QUALITY ASSURANCE -- NON-CONFORMANCE REPORT

Location: Changxing Island, Shanghai, P.R. China **Report No:** NCR-000521
Prime Contractor: American Bridge/Fluor Enterprises, a JV **Date:** 23-Nov-2009
Submitting Contractor: Zhenhua Port Machinery Company, Ltd (ZPMC), Changxing Island **NCR #:** ZPMC-0494

Reference Description: The contractor did not perform the required NDT after Heat Straightening for Segment 7BW

WELD NUMBER: SSD10-PP050-003

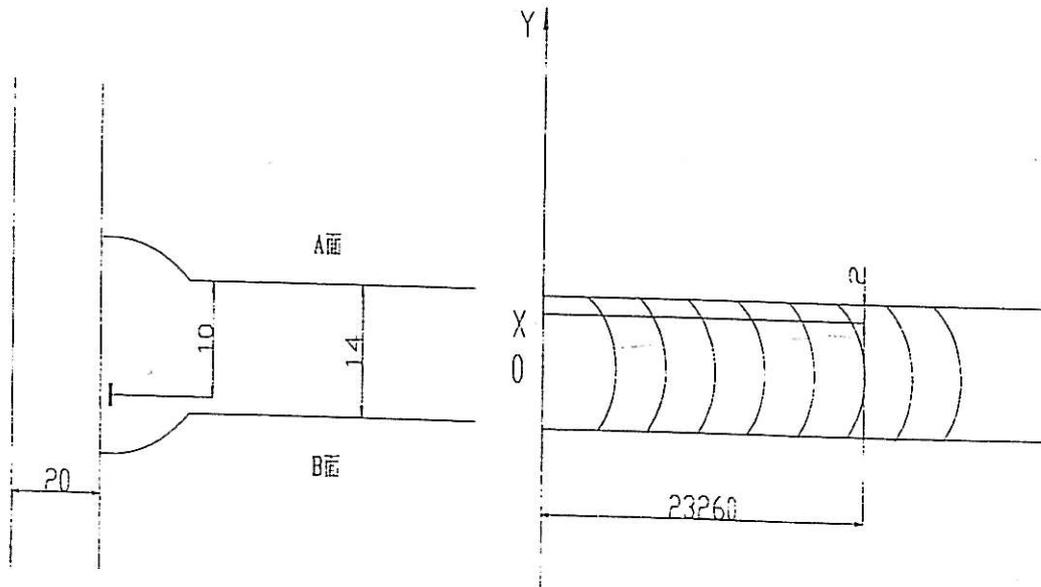
Rejected indication found by ultrasonic inspection is less than the maximum allowance aggregate length.

(UT探伤发现的缺陷总长度小于最大允许长度。) SSD10-PP050-003

1. Did not clear the weld pass completely in time.

1. Gouge or grind from nearer side from metal edge ($D \leq 0.65T$, "D" is depth of defects, "T" is thickness of metal) to remove all defects;

2. Follow repair WPS for joint preparation, preheat, and weld deposit;

3. Verify with VT no defects remain in the weld joint prior to welding;

4. Grind the repaired area flush with base metal or the adjacent weld;

5. Check the welds according to the working drawings.
